DEPARTMENT OF TRANSPORTATION

National Highway Traffic Safety Administration

Side Impact Protection Side Impact Dummy

ACTION: Notice of proposed rulemaking.

Figure 1 - SID SPINE LOWER SPACER

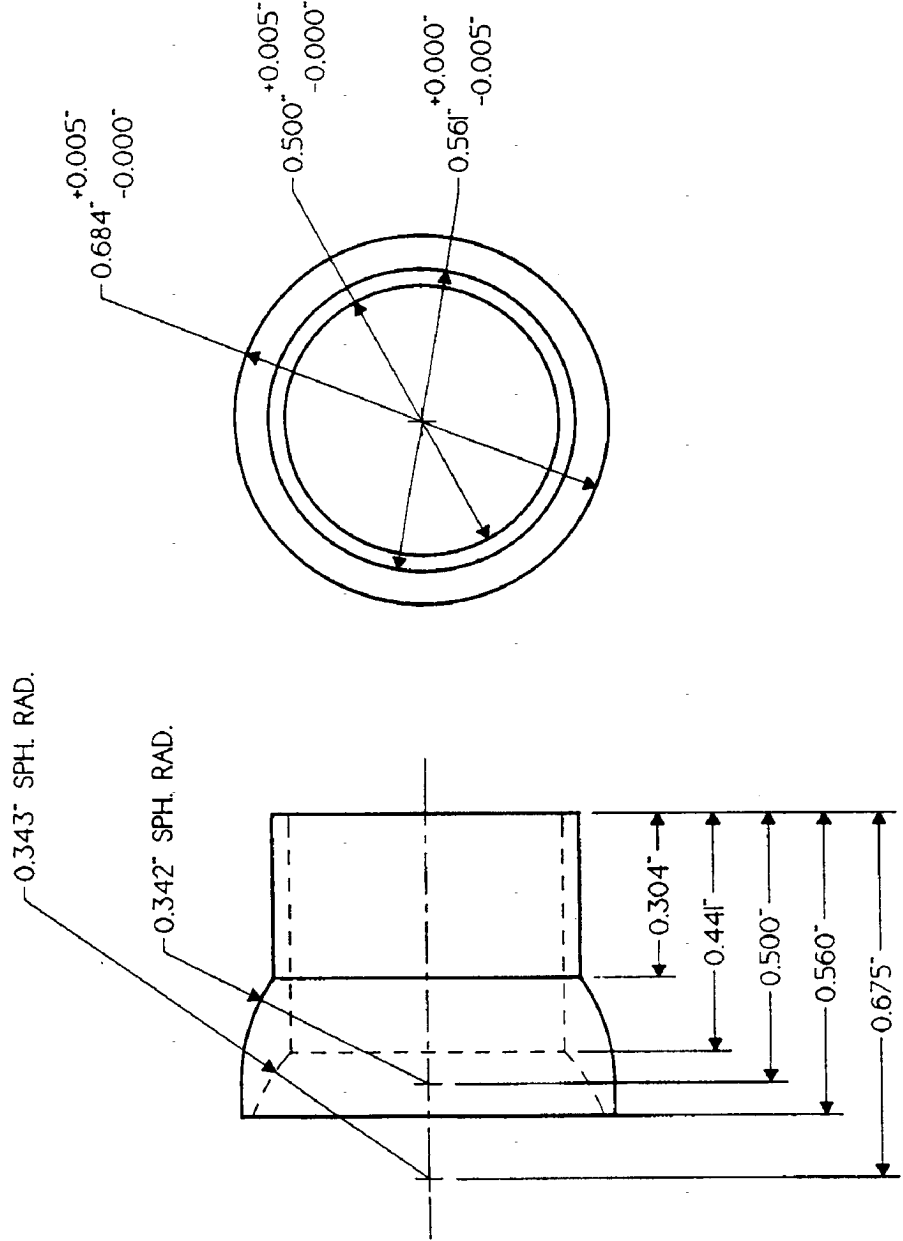
To incorporate the use of lumbar spine spacers, this proposal would replace dummy assembly drawing SA-SID-M050, revision A (dated May 18, 1994) with revision B. Revision B would include reference to:

1. Drawing Lumbar Spacers-Lower SID-SM-001, which indicates the spine lower spacer;
2. Drawing Lumbar Spacers-Upper SID-SM-002, which indicates the spine upper spacer; and
3. Drawing 78051-243 to indicate a washer.

The drawings for the SID spine lower spacer and upper spacer are depicted in this NPRM in figures 1 and 2, respectively.

(4) The lumbar spine consists of the assembly specified in subpart B (§ 572.9(a)) and conforms to drawing SA 150 M050 and drawings subtended by SA-SID-M050 revision B, dated [to be determined], including the addition of Lumbar Spacers-Lower SID-SM-001 and Lumbar Spacers-Upper SID-SM-002, and Washer 78051-243.
